L-PI-09-071
10 CFR 72.56

Prairie Island Independent Spent Fuel Storage Installation
Docket No. 72-10
Materials License No. SNM-2506

Supplement to License Amendment Request (LAR) to Modify TN-40 Cask Design
(Designated as TN-40HT) (TAC No. L24203)

ENCLOSURE 3

FIGURE A4A.10-4
CASK SHELL ACCELERATION TIME HISTORY (350HZ FILTER)

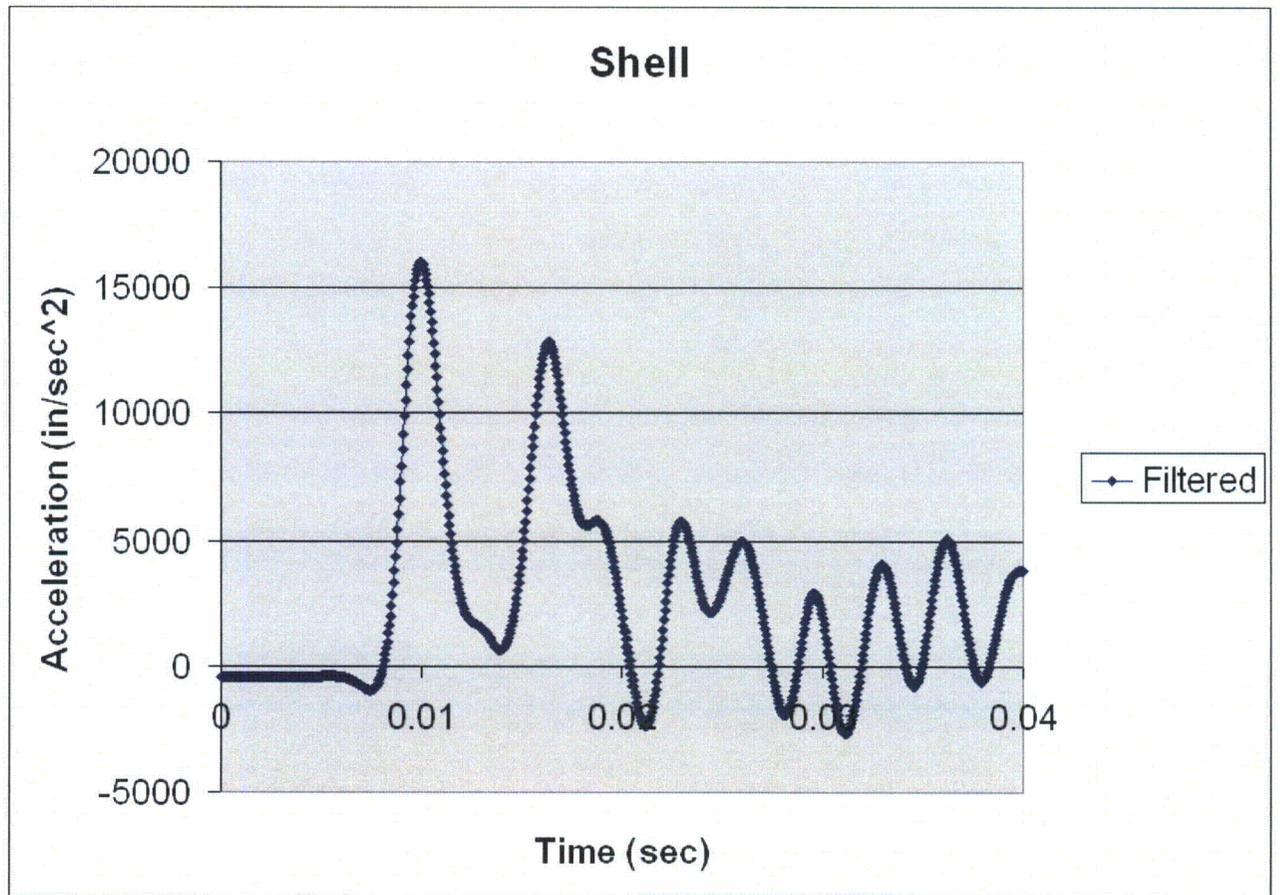
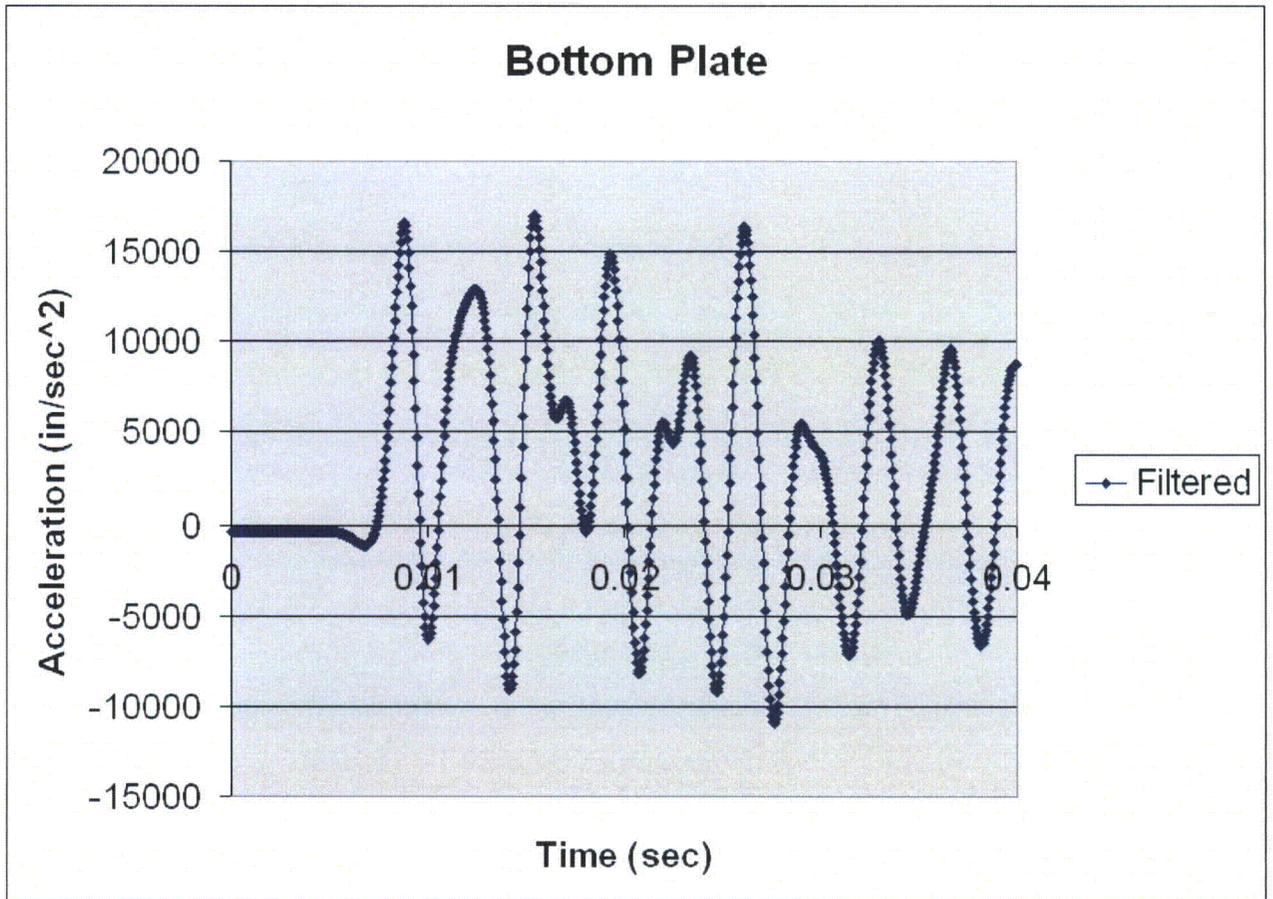
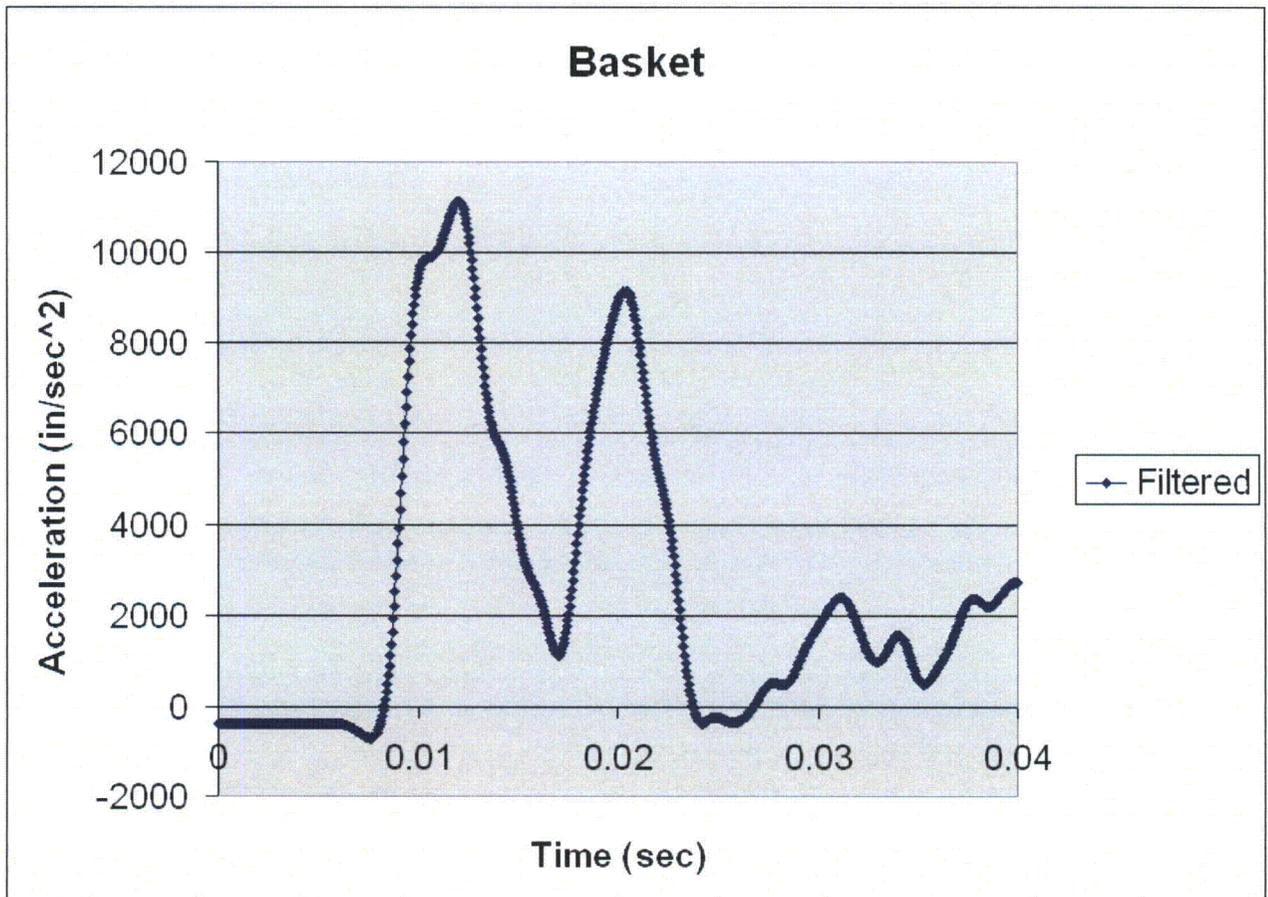
Transient dynamic analysis of the cask for the 18-inch end-drop using LS-DYNA was performed to determine decelerations and will be added to new SAR Section A4A.10. The calculation to determine decelerations using EPRI NP-7551 will be removed from Section A8.2.8.2.1.

The resulting rigid body acceleration time histories were computed by LS-DYNA. The rigid body accelerations were computed for the bottom plate, circumferential shell, and basket representation. The parts can be seen in Figure A4A.10-3.

DRAWING NO. TN40HT-72NP-21 SCALE NONE SHEET 1 OF 7 REVISION 2

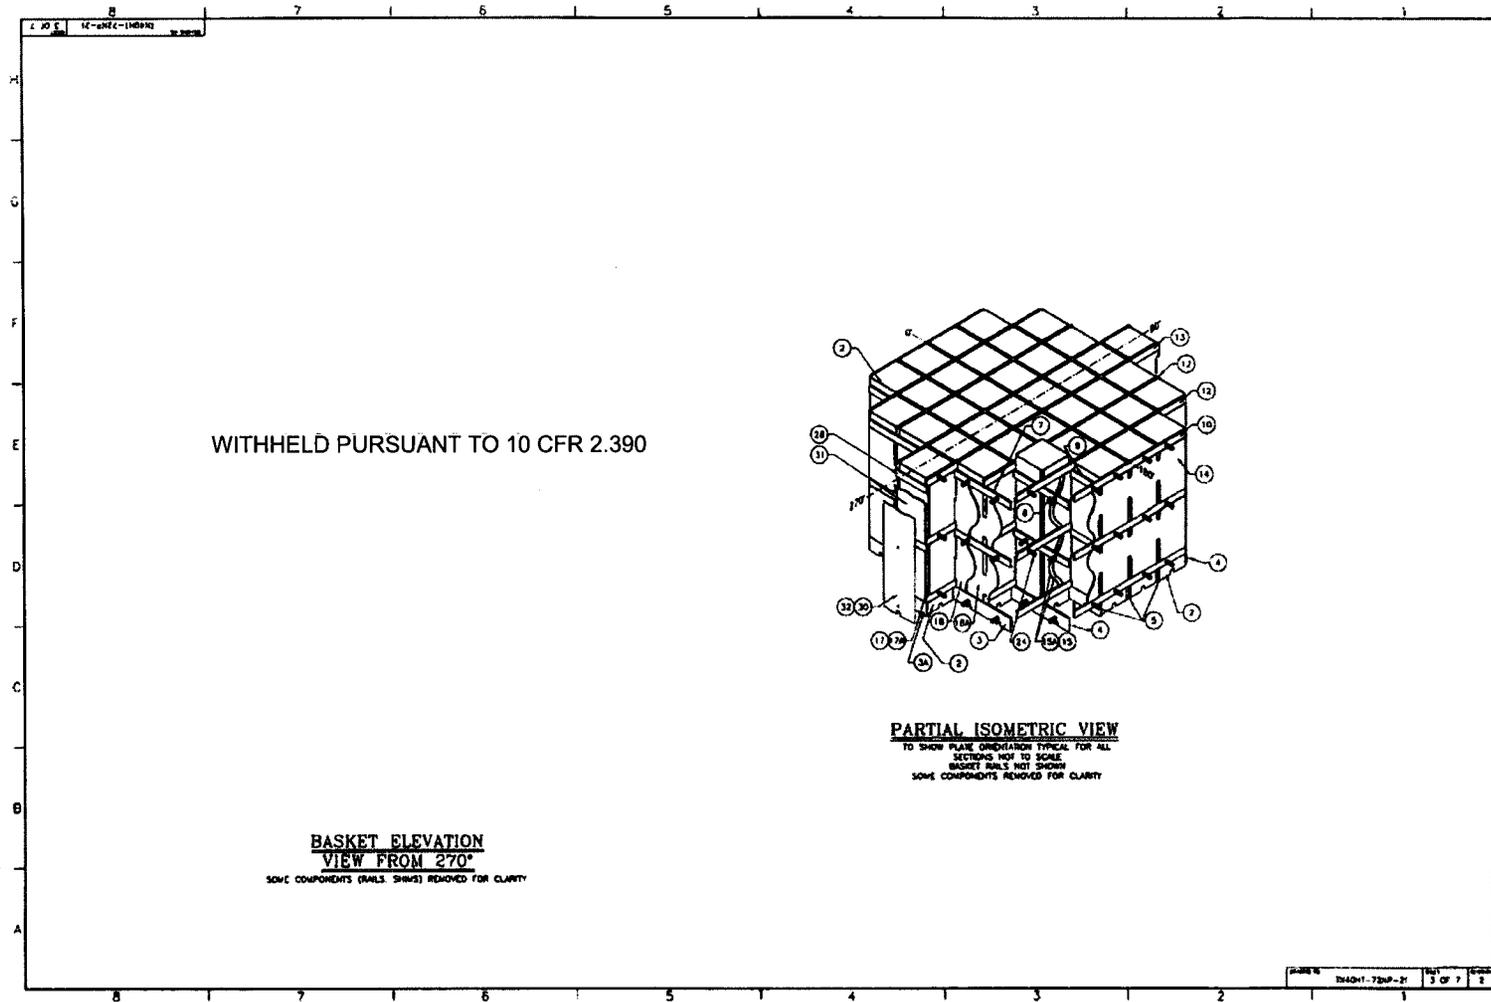
Note Number 14 on SAR Drawing TN40HT-72-21, Sheet 1 of 7, calls for the seam welds of the fuel compartments to be 100% penetration welds and to meet the requirements of NG-3352.

Note Number 13 on SAR Drawing TN40HT-72-21, Sheet 1 of 7, calls for the capacity of the fusion welds to be demonstrated by qualification and production testing. This alternative to the requirements of NG-3352 is discussed in SAR Section A3.5.
